TECHNICAL EVALUATION REPORT

MASONRY WALL DESIGN

PRAIRIE ISLAND NUCLEAR GENERATING PLANT UNITS 1 AND 2

August 16, 1983

DETAIL-5

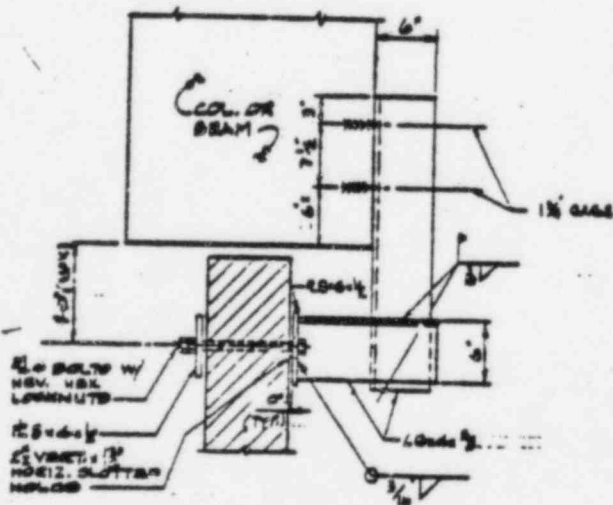
Most of the walls were provided with supports on both faces, with the exception of a few walls which were supported only on one face of the wall. However, thru-bolts and special types of support configurations were used to restrain the walls in the transverse direction. Details 3, 5, and 11 of drawings in Appendix B show the details of the wall supports either on top of or on the sides of the wall.

For those walls to which additional supports were introduced to reduce the span, thru-bolts were used at either the top or the edge of the wall support to provide seismic restraint of the wall (similar to the configuration in Detail 5 in Appendix B) in the transverse direction. All of these walls are reinforced and connected to the floor with dowels. Along the supported beam, expansion bolts were used on alternate locations on the near side and far side of the supported beam web (see Details 18A, 9A, 10 of drawings in Appendix B).

The review of modification drawings as described above indicates that the modifications are adequate and that the modified walls satisfy the SGEB criteria with regard to the allowables.
